10/15/19 Pre-Proposal Meeting for Preliminary Engineering for Mann Valley

MANN VALLEY – PRELIMINARY ENGINEERING
CITY OF RIVER FALLS, WI

PRE-PROPOSAL MEETING
TUESDAY, OCTOBER 15, 9:00 AM
RIVER FALLS CITY HALL – TRAINING ROOM

EXHIBIT E

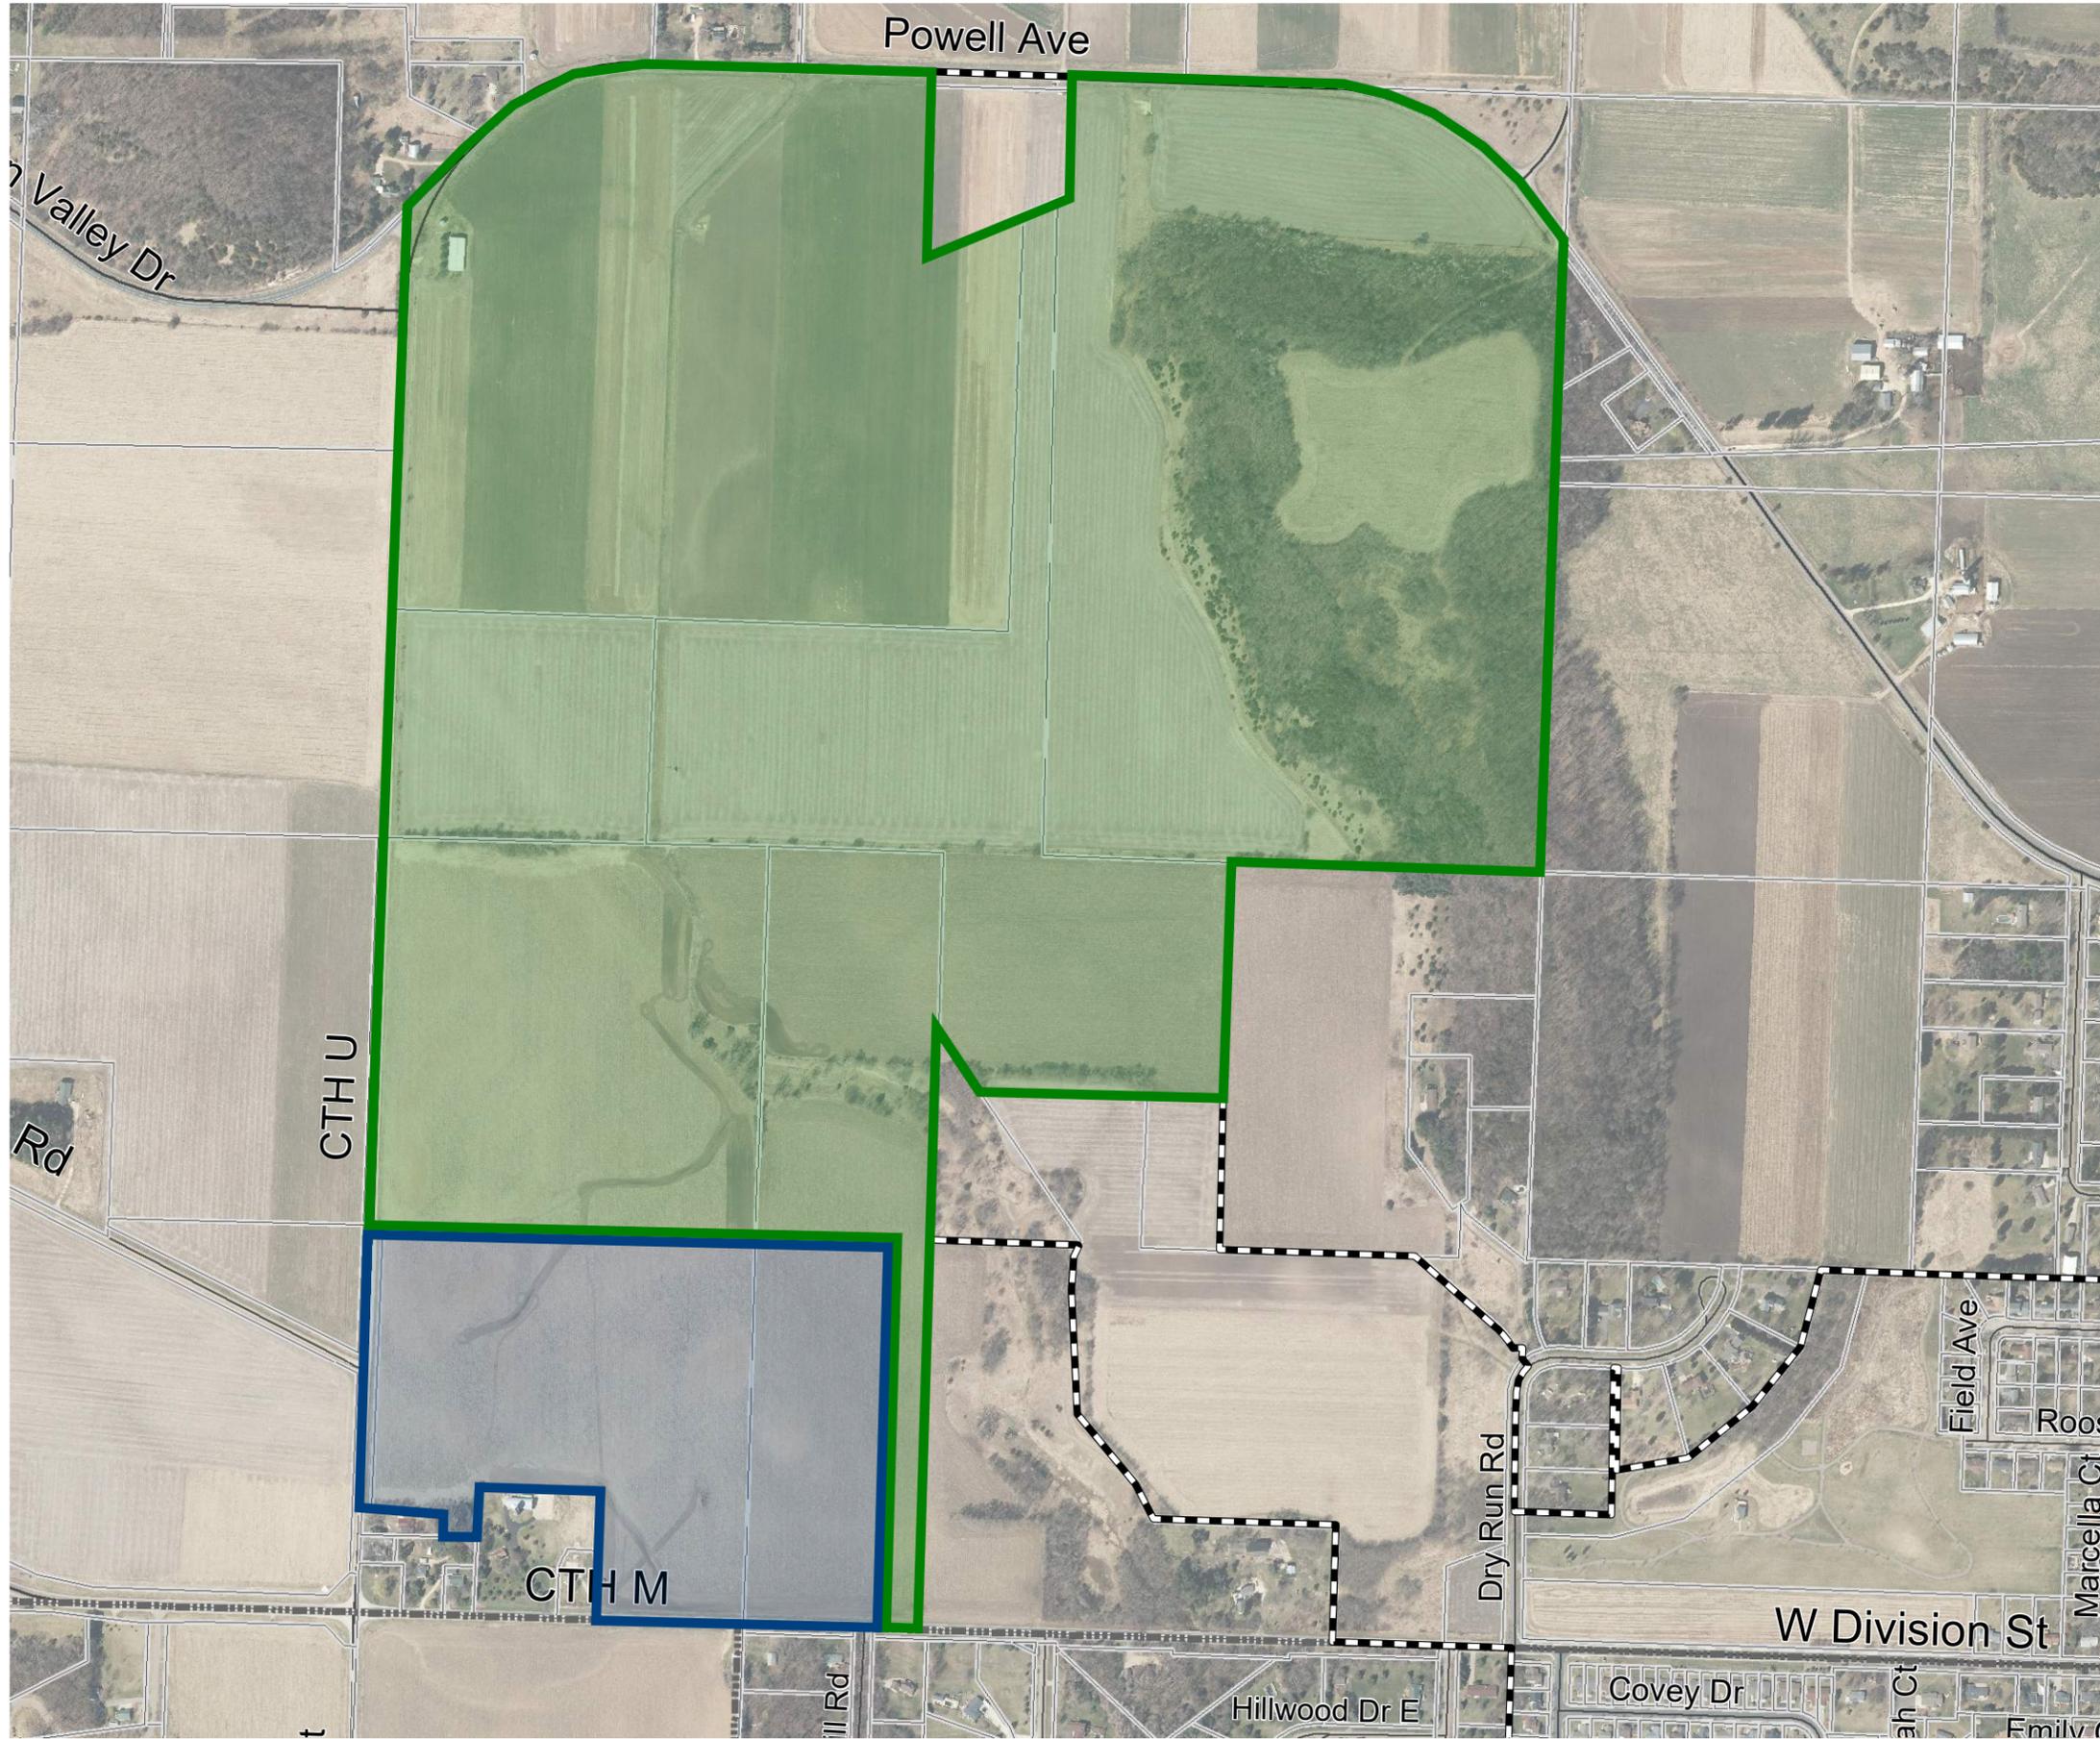
Question 2: Does the City want a basic ALTA survey or specific items from Table A?

The City would like the consultant to complete Items 1, 3, 13, and 18 from Table A in addition to the minimum requirements of the ALTA survey. Exhibit E has been revised for the ALTA survey (see attached). The City will obtain the title commitments for the ALTA survey after a consultant agreement is in place.

**Mann Valley Preliminary Design
Radio Road Water Main
Connection Location**

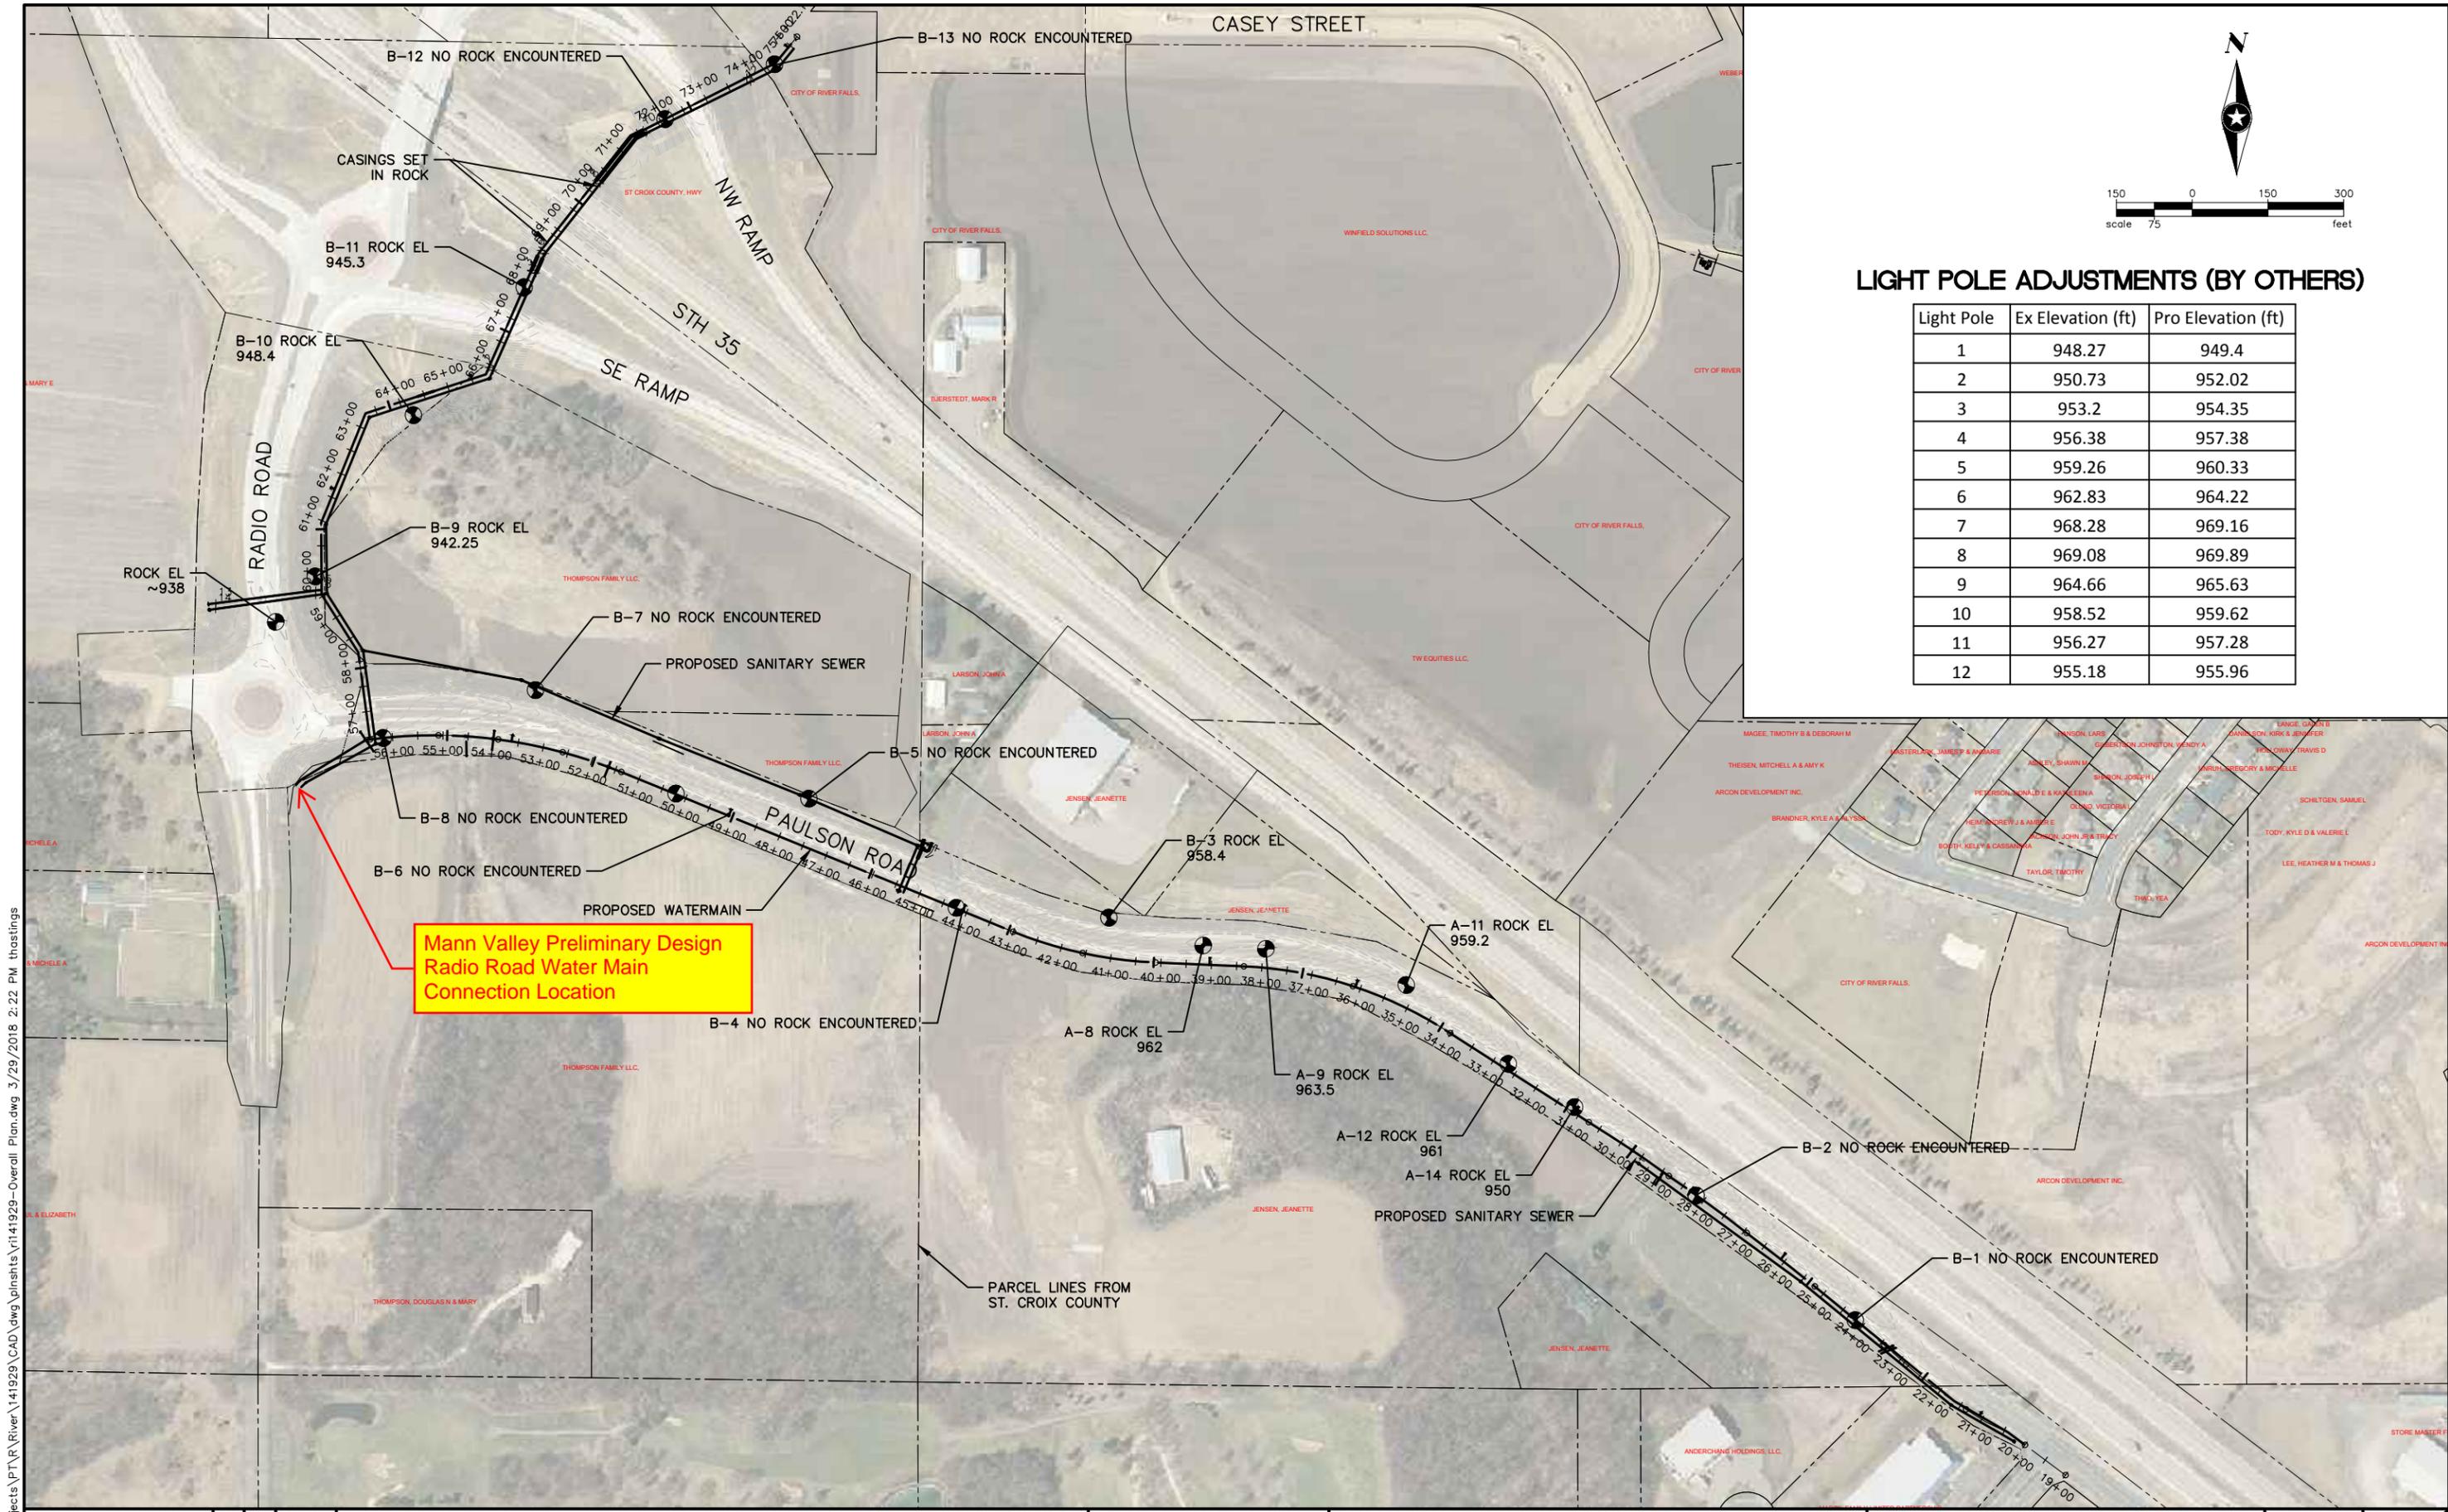
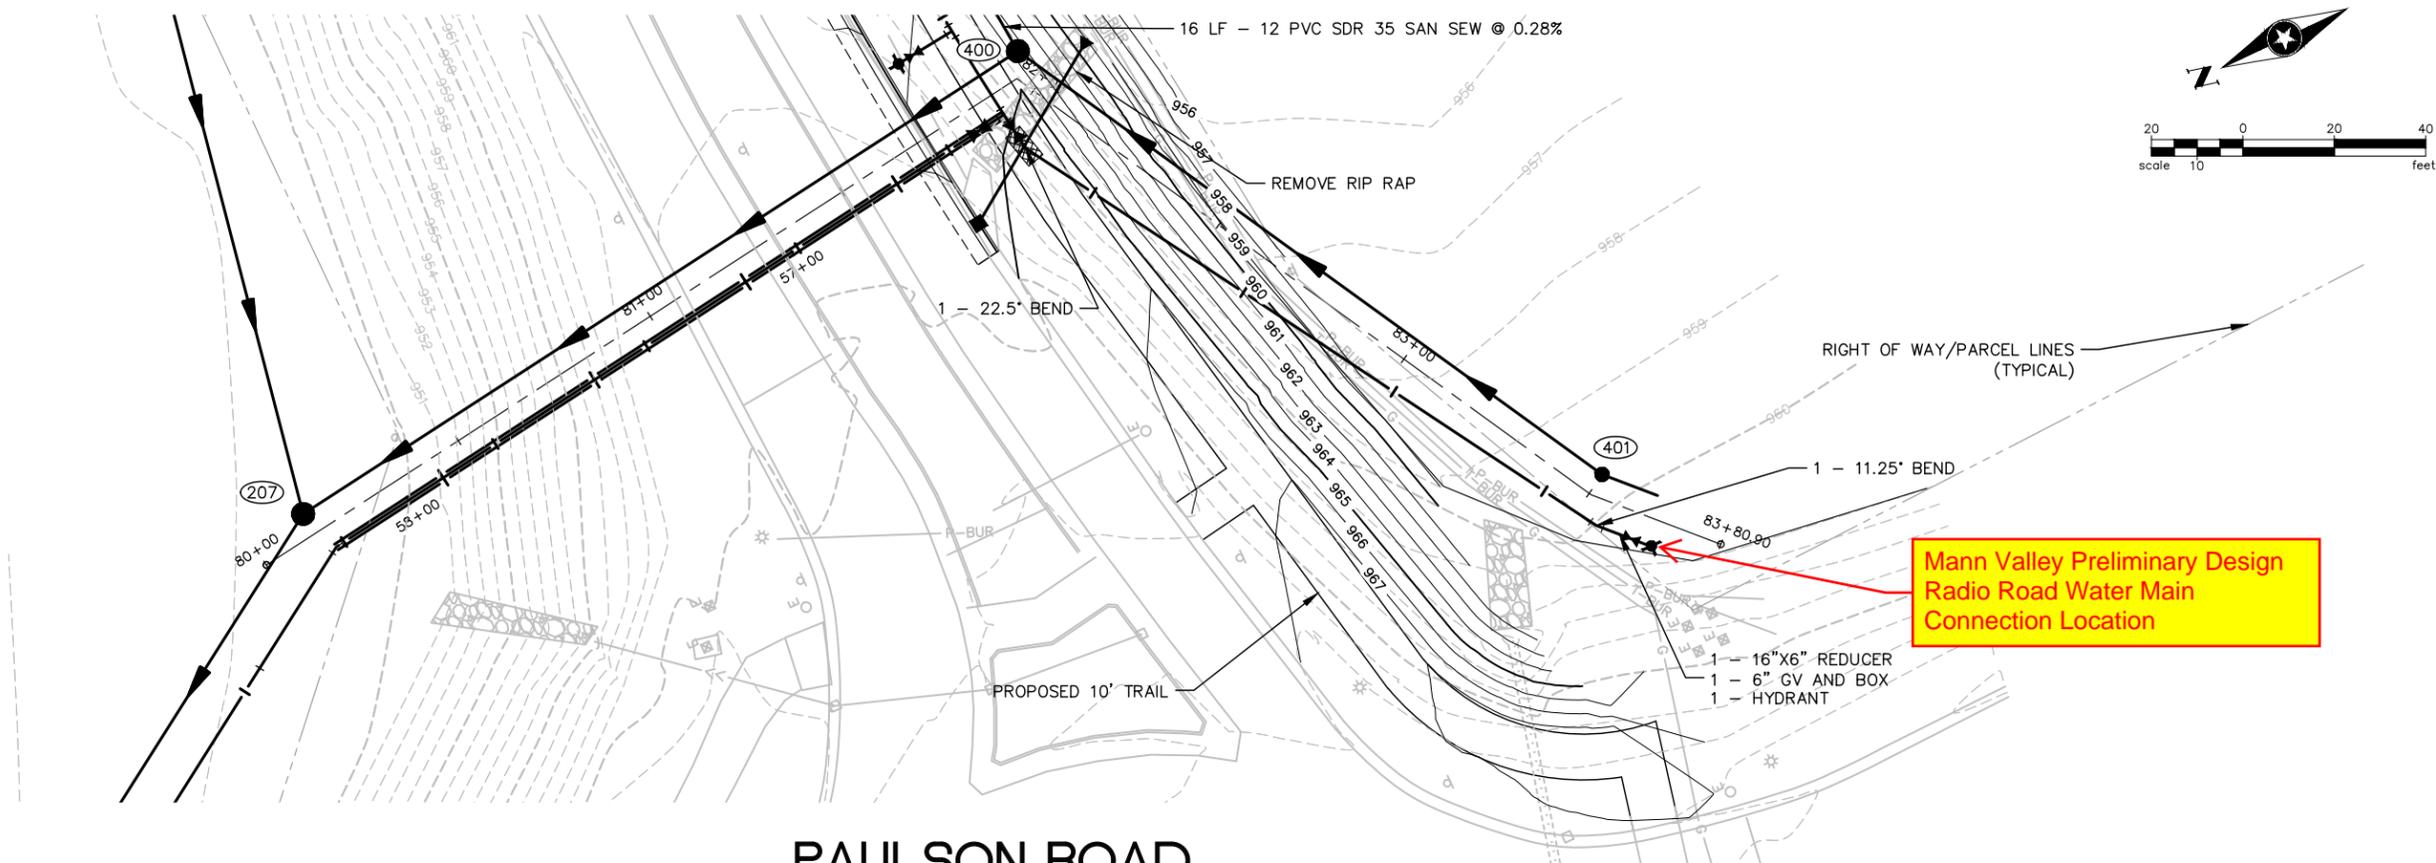
Question 12: Does the 30 percent plan include the water loop?

Question 17: How can consultants obtain the latest GIS information?

The 30 percent plans should include the water main extension along Radio Road to the future water main connection at Paulson Road. Using County contour surface data is sufficient for 30 percent design.

Contact City Engineer Crystal Raleigh for shapefiles of the corporate limits and water/sewer infrastructure in DeSanctis Park. The North Loop Extension water plan is attached.
